TECHNICAL SERVICE BULLETIN

2 B 24

Radio Interference From
Wiper Motor

All Models with Two Speed
Wiper Motors

Braided ground
wire on Austin
America installation.

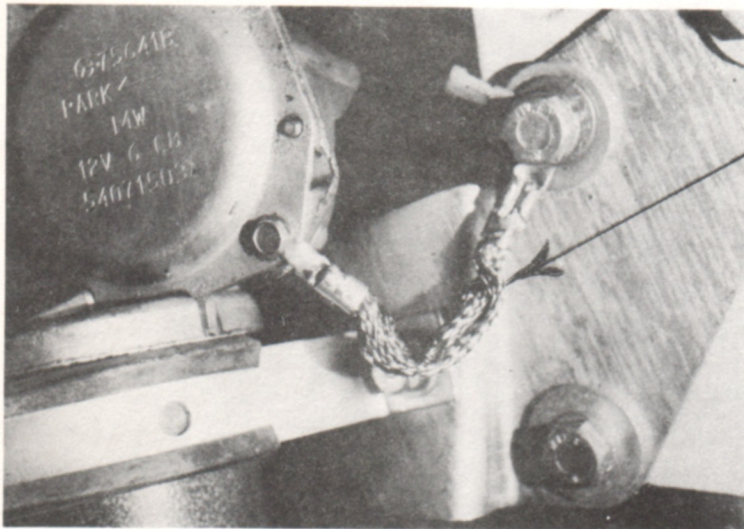
Complaints of radio interference from the wiper motor can be eliminated by the addition of a heavy ground wire (braided type is most suitable) from one of the wheel box cover screws to a good ground point.
